NUMBER: SB 550-32-003, Rev E
MODEL: ECLIPSE 550®
SUBJECT: Left Hand MLG Trunnion Repair/Replacement

This bulletin repairs or replaces the main landing gear trunnion.

Revision E of this Service Bulletin limits the effectivity and updates the compliance section.

Figure 1. MLG Main Fitting Nameplate Location

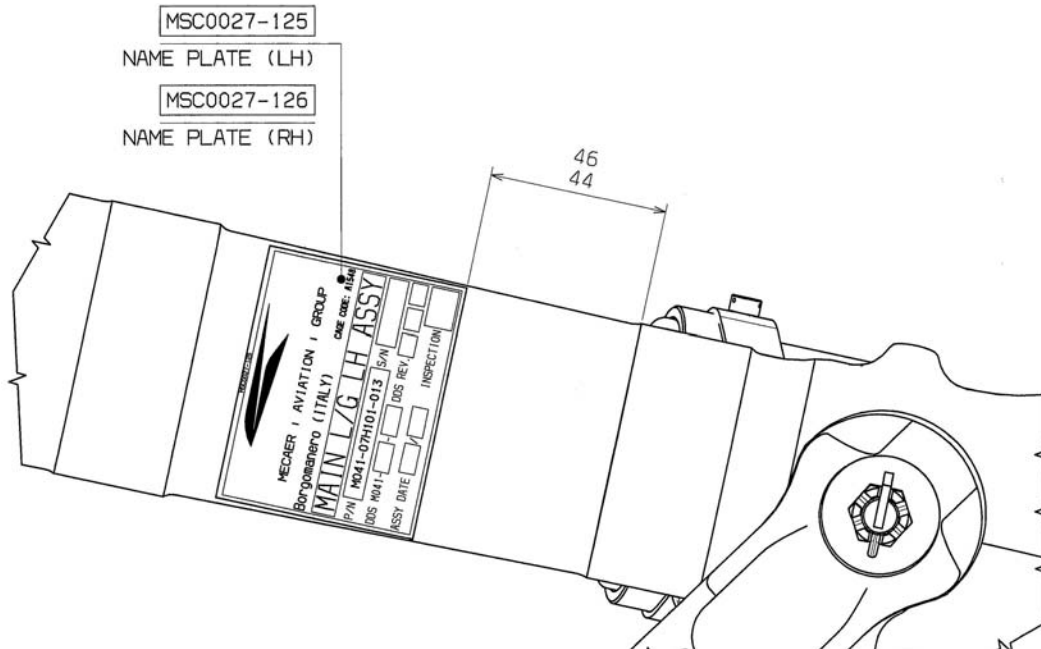
- (3) MFG DATE/ASSY DATE to remain as on the original nameplate (do not change the date to the current date).
- (4) Original nameplate shall have a large black “X” marked across the nameplate from corner to corner with permanent marker to void the nameplate. Original nameplate to remain attached to the old Main Fitting.
- (5) Locate position for new nameplate installation on the new MLG Main Fitting 44-46 mm (1.73-1.81 inch) up from the lower strengthening band in accordance with [Figure 1](#).
- (6) Pre-bend new Nameplate to conform to the contour of Main Fitting.

- (7) Prepare the Main Fitting surface in the location of the nameplate by thoroughly cleaning the surface with Aliphatic Naptha TT-N-95B Type II (or equivalent).
- (8) Ensure the Main Fitting surface is completely dry after cleaning by using a clean dry cloth.
- (9) Remove adhesive backing from the nameplate.
- (10) Apply Epoxy Adhesive MMM-A-132, Type 1, Class 3 (Metalset A4 or equivalent) under the entire surface of the nameplate.
- (11) Attach the nameplate to the MLG Main Fitting in the correct location.

- (12) Apply liberal bead of adhesive around all edges of nameplate.
- (13) Temporarily secure nameplate to Main Fitting using non-marking tape (Masking Tape or equivalent).
- (14) Allow adhesive to dry.
- (15) Remove temporary tape.
- (16) Install Trunnion per Section F. — MLG Main Fitting Installation.

Figure 2. Trunnion Identification Pad Area

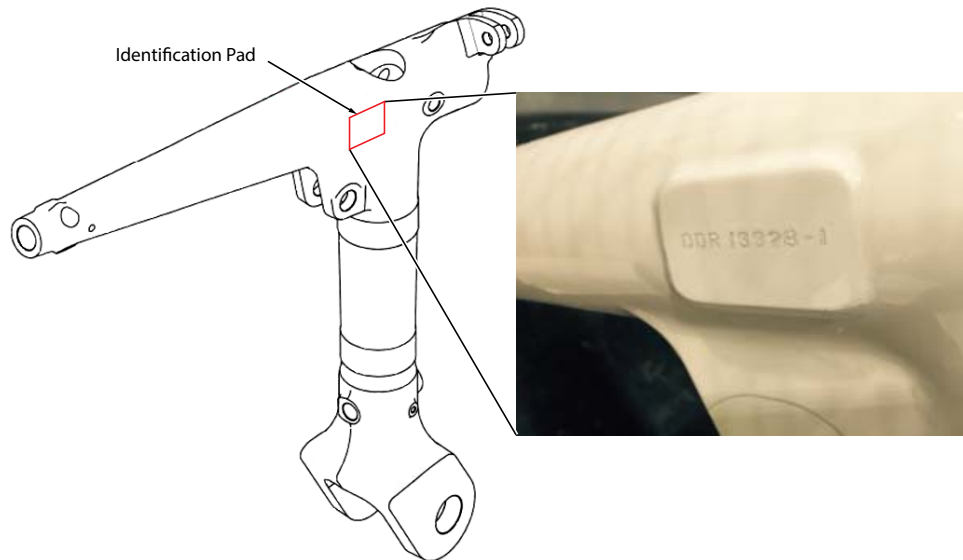
- (1) Ensure the replacement trunnion contains at least one of the following (Refer to Figure 2):
 - Marked indication of SB completion on or near the identification pad area.
(Accomplished after repair procedure.)
 - Engraved DDR# from Mecaer on the identification pad.
